RE: United Power Stonehouse Substation Conditional Use Permit – RCU2025-00008 Submittal 3

Ulteig on behalf of United Power, Inc. respectfully delivers this third submittal for the Stonehouse Substation Conditional Use Permit application RCU2025-00008.

Adams County Comments and United Power/Ulteig Responses

Landscaping Comparisons

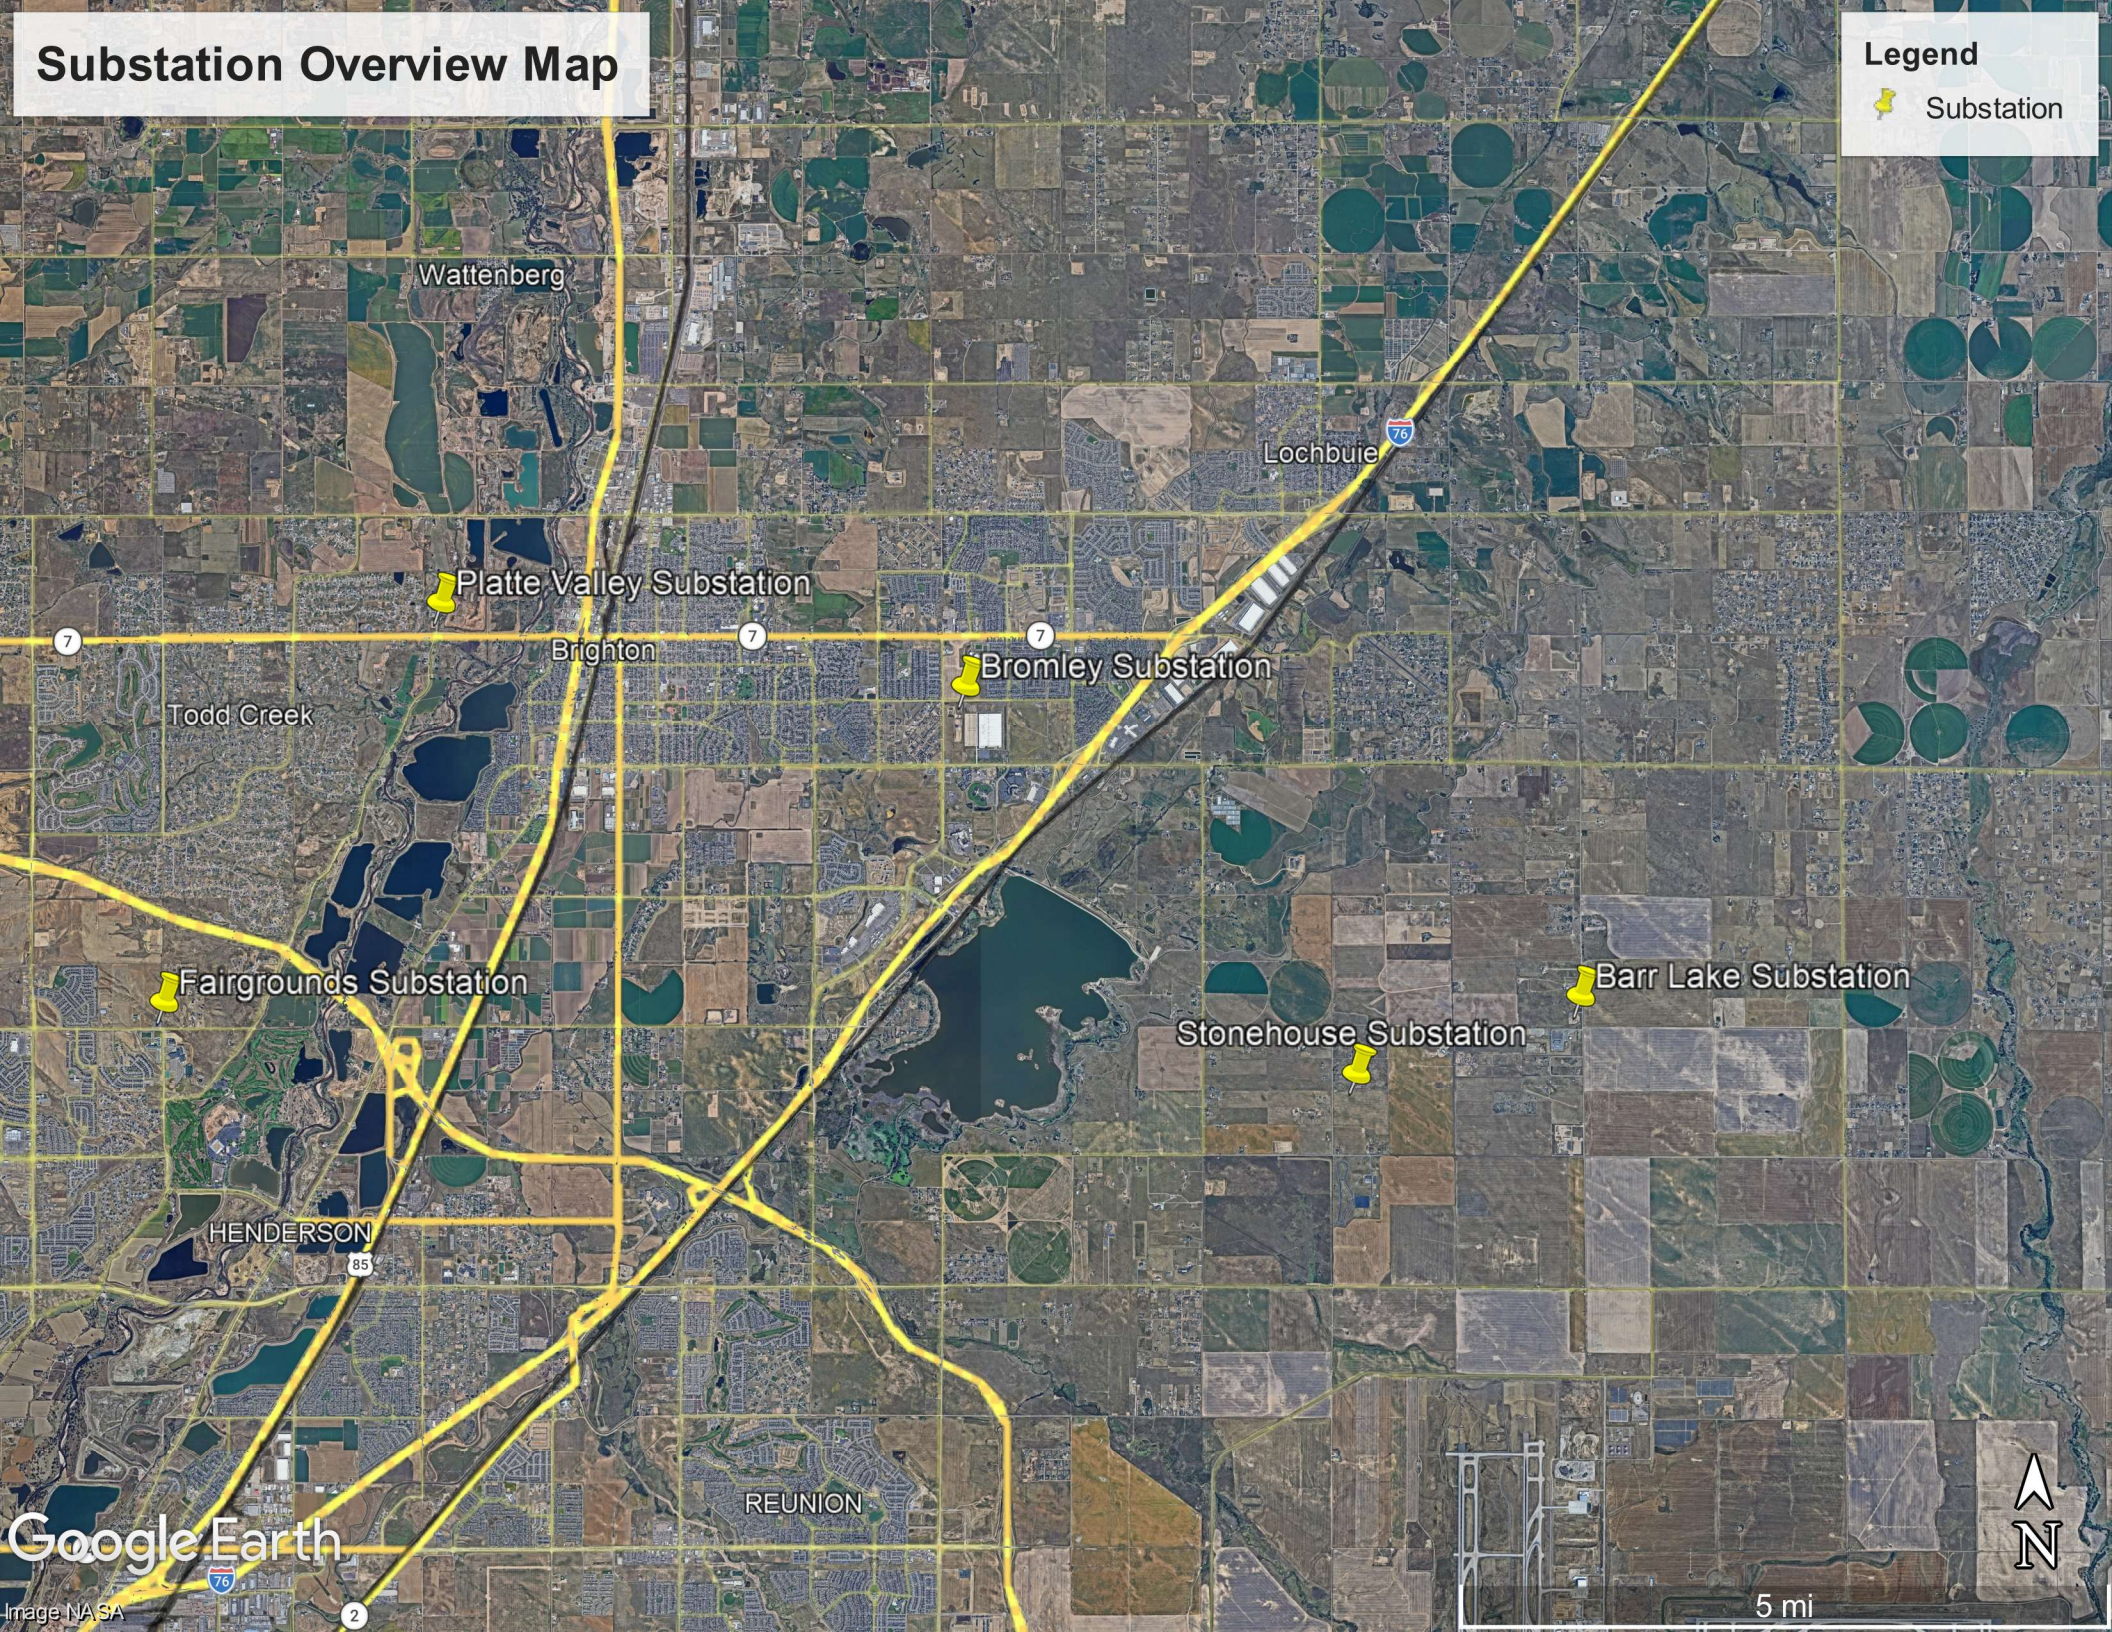
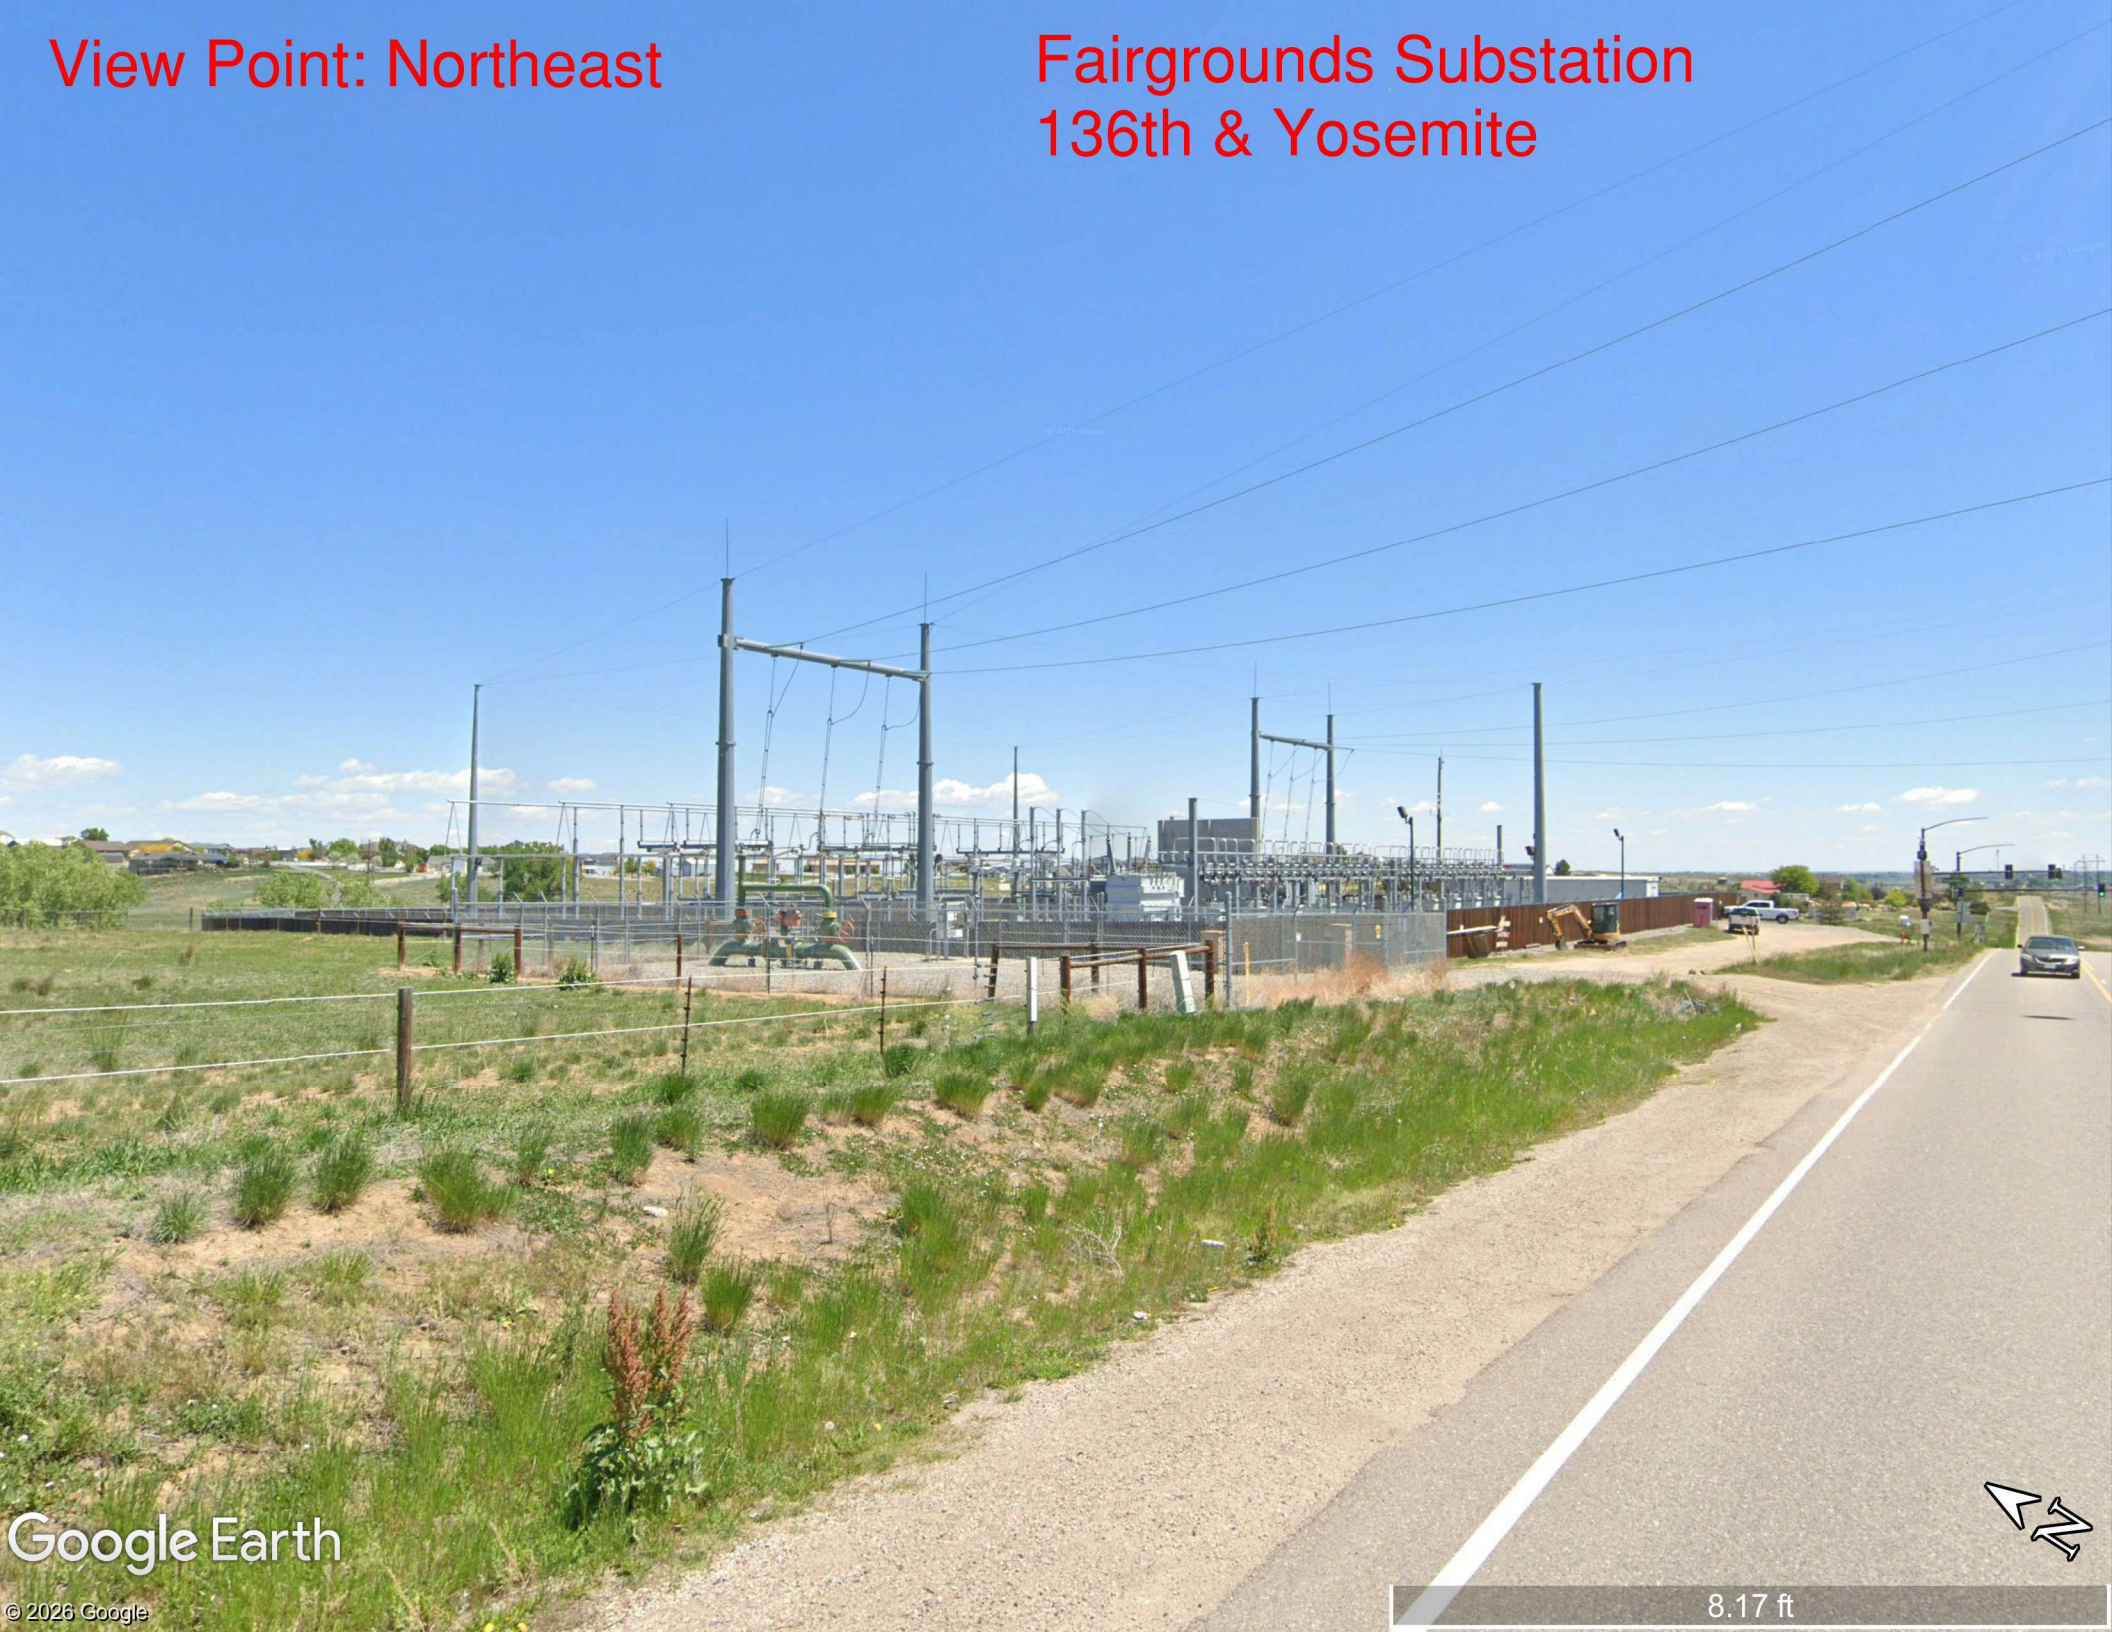
We would like for you to explore more opportunities for landscaping. The site is located within a portion of the county where landscaping relief is more difficult to justify. Have you explored native plants and xeriscaping?

For reference, we are including a series of maps/photos that show United Power's existing substations in the surrounding area and the lack of landscaping at each.

United Power has gathered maps and photos from 4 of their existing substation sites, within the vicinity of the proposed Stonehouse Substation, to demonstrate the on-site landscaping in order to help justify the absence of landscaping at the proposed Stonehouse Substation. This is a supplement to the response that was provided to address the landscaping comments from County staff.
